## June BAR Action - 416-418 West Main Street

BAR 20-06-01

416-418 West Main Street

New roof and fenestration

416-418 W. MAIN ST.	ROOF & CLERESTORY	<b>MATERIALS</b>	TOPIA design	3.25.2020	22/22
---------------------	-------------------	------------------	--------------	-----------	-------

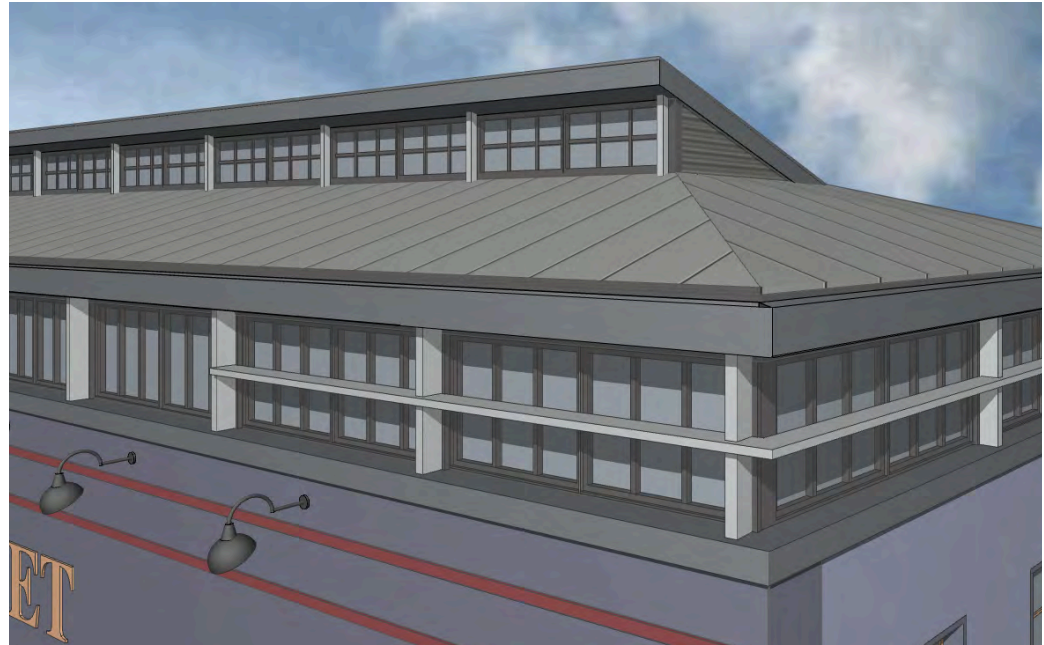
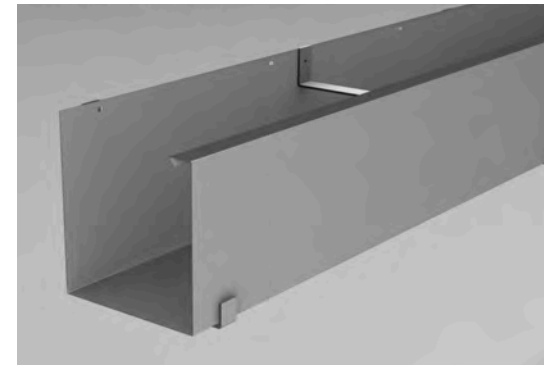
- *that the top of the original building's parapet be painted to match the belt coursing of the building itself around the complete perimeter of the original structure*
- *that the roof structure have a monochromatic finish, as specified as RAL 7012 Basalt Grey in the applicant's submittal*
